Access Compliance Report

Public Rights-of-Way

Intersection ID: N/A	Main Street: PERIWINKLE_HILL_CT	Cross Street: N/A	Location: N
ADA ID: 9FF505D62592	Ramp Type: Perp	Initial Pass/Fail: Fail	Overall Compliance: No
Severity Score: 12.5			
Codes/Mitigation Info/Possible Solution		Field Measurements/Component Compliance

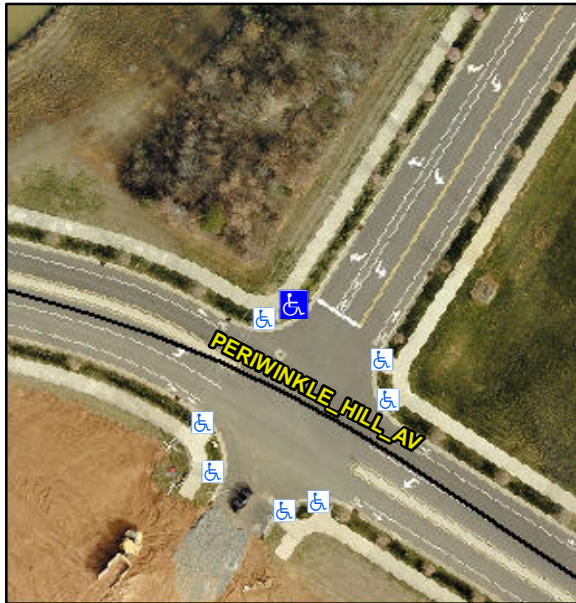
Compliance	Description	Data	Compliance	Description	Data
N/A	Ramp Length (in)	94.0	No	Ramp Slope (%)	10.7
Yes	Ramp Width (in)	94.0	Yes	Ramp XSlope (%)	1.6
N/A	Flare Type LT	N/A	N/A	Flare Type RT	N/A
N/A	Flare Slope LT (%)	N/A	N/A	Flare Slope RT (%)	N/A
N/A	Flare Traversable LT?	N/A	N/A	Flare Traversable RT?	N/A
N/A	Landing Length (in)	N/A	N/A	DWS Provided?	N/A
N/A	Landing Width (in)	N/A	N/A	DWS Contrast?	N/A
N/A	Landing Slope (%)	N/A	N/A	DWS Length (in)	N/A
N/A	Landing X Slope (%)	N/A	N/A	DWS Full Width?	N/A
N/A	Landing Curb? (Y/N)	N/A	N/A	DWS Offset (in)	N/A
N/A	Shared Landing?	N/A			
N/A	Gutter Ponding?	N/A	N/A	Gutter Slope (%)	N/A
N/A	Gutter Lip Ht (in)	N/A	N/A	Gutter X Slope (%)	N/A
N/A	Painted X Walk1?	No	N/A	Painted X Walk2?	N/A
	X Walk 1 Direction	To SE		X Walk 2 Direction	N/A
N/A	X Walk 1 Width (in)	N/A	N/A	X Walk 2 Width (in)	N/A
	X Walk 1 Slope (%)	4.9		X Walk 2 Slope (%)	N/A
	X Walk 1 X Slope (%)	0.7		X Walk 2 X Slope (%)	N/A

Remove & Replace Entire Ramp.

R304.2.2
